UNITED STATES PATENT AND TRADEMARK OFFICE

10/522,889

Office Action Summary	Application No. 10/522,889	Applicant(s) HENGELMOLEN, RUDY	
	Examiner Eric Blatt	Art Unit 3734

DETAILED ACTION

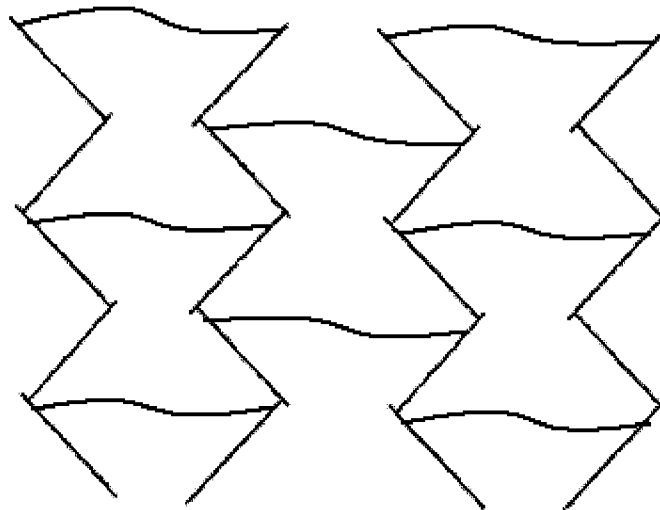
Burgermeister discloses a tubular liner (Figures 8-10) for insertion into a duct comprising first and second ends and a lumen such that fluid flow occurs through said lumen from the first end to the second end. Regarding the claimed strut patterning, Burgermeister discloses that the tubular liner has radial portions 410 joined together by connecting members 410 (Figure 8A). Although radial portions 410 comprise curved struts, it can be seen that these radial portions essentially comprise zig-zagging struts. Burgermeister discloses that by affixing the connecting members near the inner vertexes of adjacent radial zig-zagging portions, the stent may be caused to increase in length as it expands radially. (Figures 9 and 10) Extrapolating the arrangement of the connecting member shown at the top of Figure 10 across an entire stent, the strut pattern would appear as shown in the sketch below.

Burgermeister does not explicitly disclose that the connecting members may be affixed exactly at the inner vertexes, but rather teaches that the nearer the connecting members are attached to the inner vertexes, the more the stent will increase in length as

it radially expands. It would have been obvious to one of ordinary skill in the art at the time of the invention to affix the connecting members to the inner vertices in order to maximize the lengthening property as taught by Bergermeister. Thus, Bergermeister teaches a tubular liner comprising a plurality of adjacent radial loops wherein each loop comprises a plurality of interconnected hexagons as claimed in claims 2-4. The connecting members comprise first and second hexagon sides parallel to the longitudinal axis.

Regarding claims 5-8, the bands interconnected hexagons of Bergermeister are oriented radially. It would have been obvious to one of ordinary skill in the art at the time of the invention to modify the apparatus of Bergermeister by orienting the bands of interconnected hexagons longitudinally to form elongated strips since such a modification would have merely required a rearrangement of the existing parts of the device and would not have produced unexpected results. Additionally, such an arrangement would also have been useful in reducing foreshortening of the stent during radial expansion. Reoriented as such, the connecting members comprise first and second hexagon sides perpendicular to the longitudinal axis.
